REGIONAL REVIEW FINDING

ARC REVIEW CODE: R1905281

Name of Proposal: Marietta Boulevard Mixed Use (DRI 2929)

TITLE
ZONING PLAN

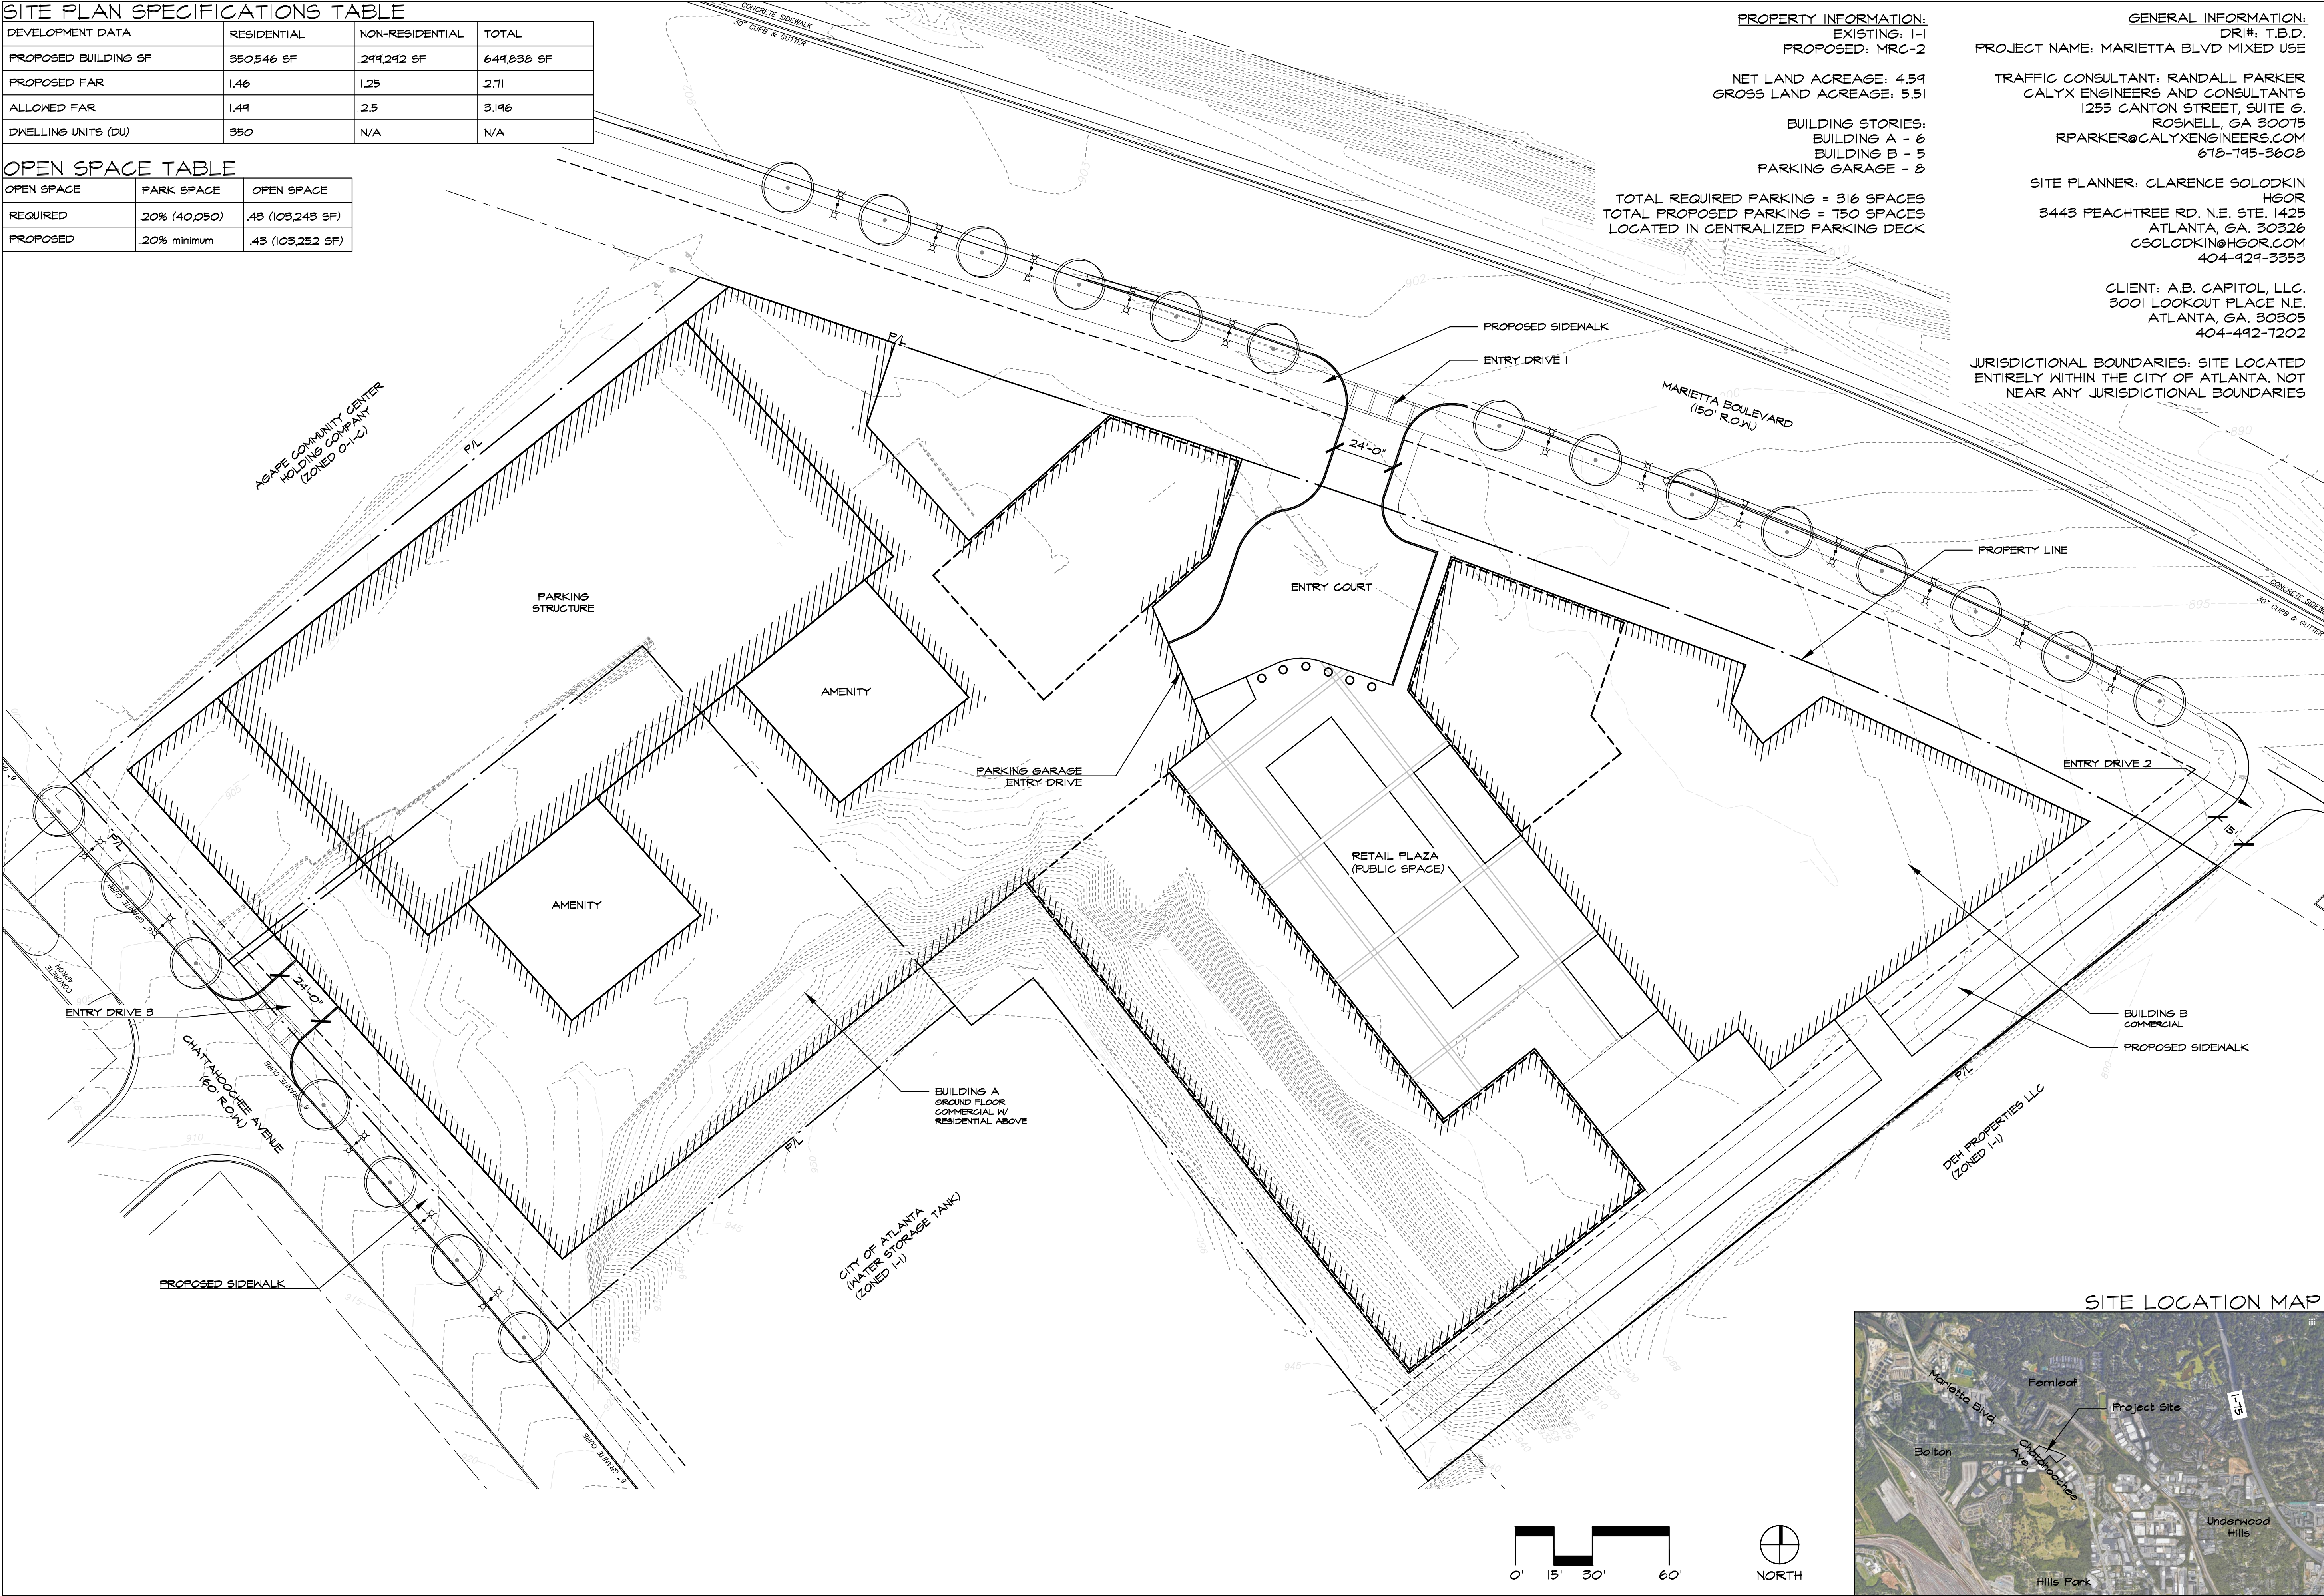
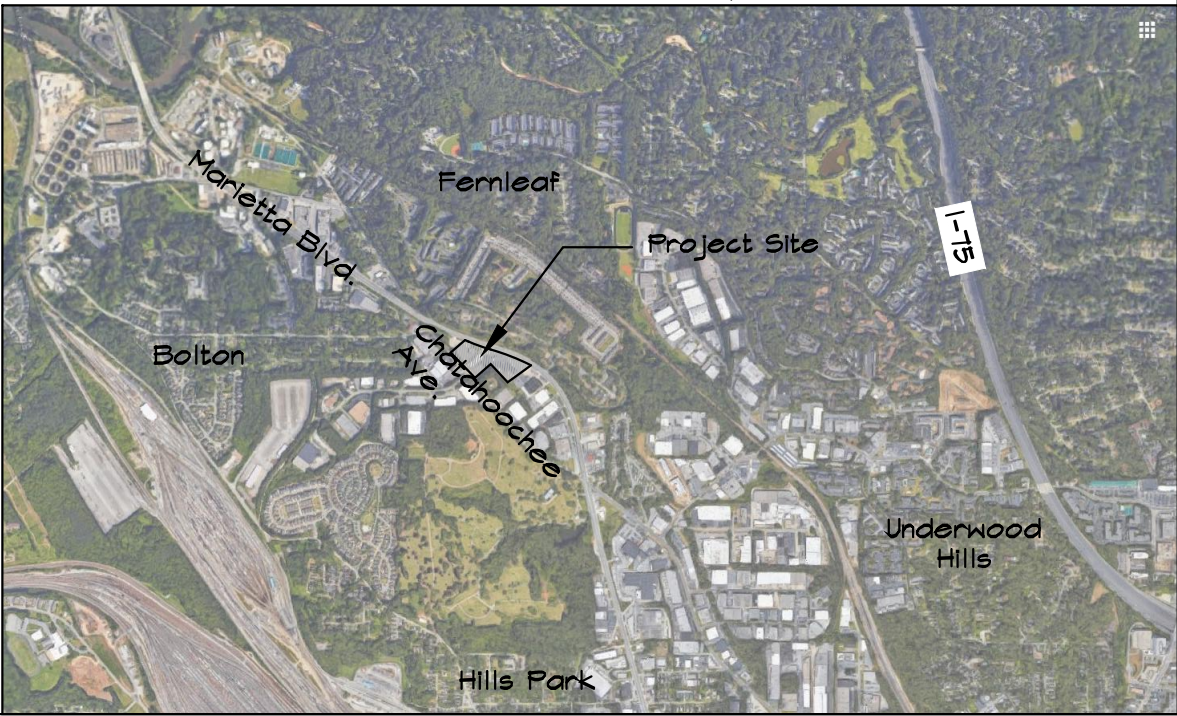
This includes access for bicyclists and pedestrians – including those coming from MARTA bus stops – at the main site driveway (Site Driveway 1) on Marietta Blvd. The submitted site plan does not show a clear connection from the sidewalk fronting Marietta Blvd., through the setback, to the entry court and retail plaza.
